**Economic Commission for Europe****Inland Transport Committee****World Forum for Harmonization of Vehicle Regulations****Working Party on Lighting and Light Signalling (GRE)****Sixty-Ninth session**

**Regulations Nos. 3, 4, 6, 7, 19, 23, 38, 65, 69,  
70, 77, 87, 91, 98, 112, 113, and 119****Proposal for Supplement 6 to the 01 series of amendments to  
Regulation No. 69 (Rear marking plates for slow-moving  
vehicles)****Submitted by the expert from Germany\***

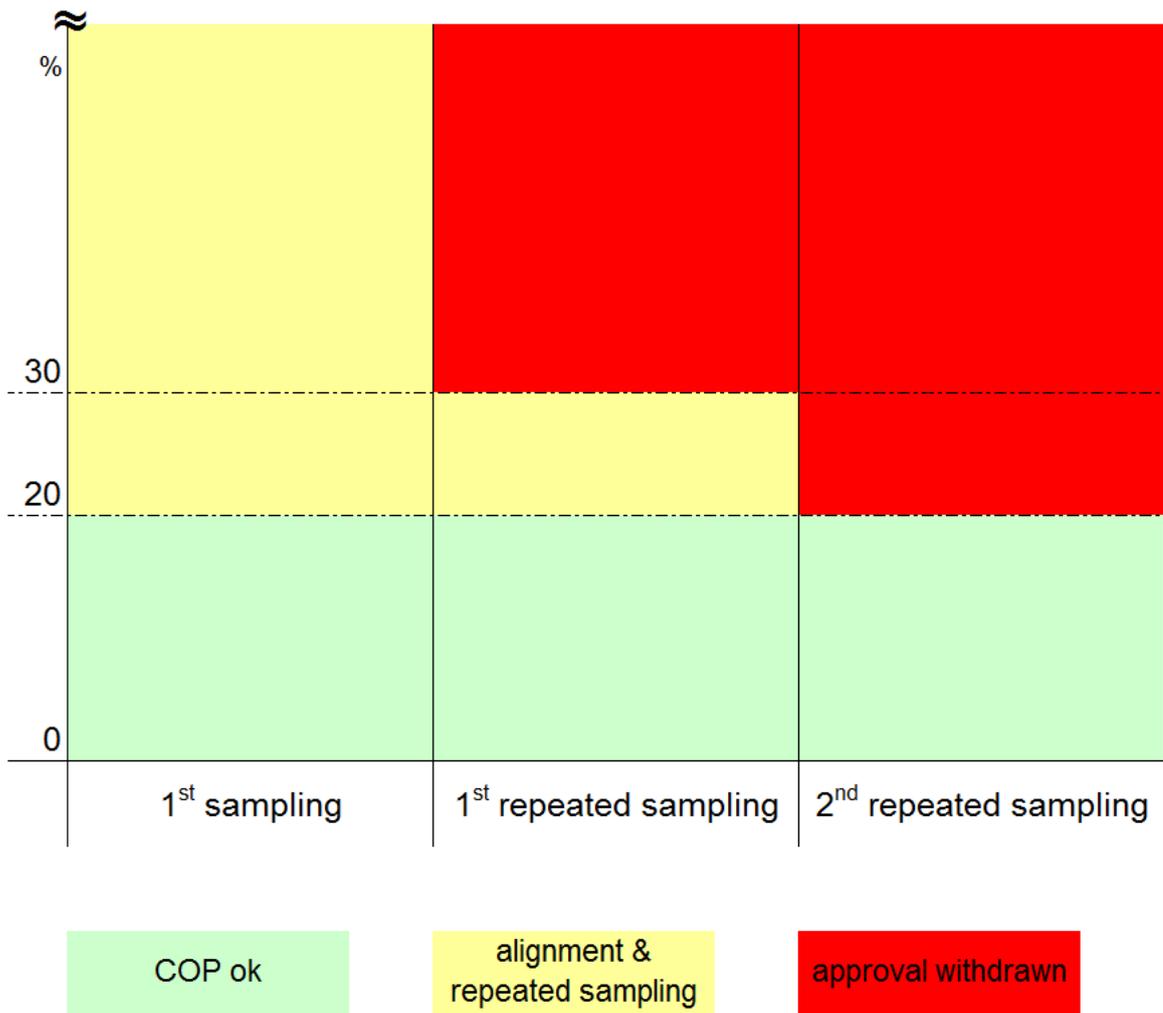
6. CoP is now described in a clear structured stepwise process (with limited steps), which gives the manufacturer the chance in the first step - in the case of deviations of more than 20 per cent - to align his production process. Also, the CoP process can be completed earlier when the first two samples are in the full specifications.

7. The proposal details the "third step" which defines the condition where the approval shall be withdrawn, when after the second repetition of this process the manufacturer was not in the position to "align" his production process in the correct way.

8. The attached drawing shall demonstrate this stepwise process.
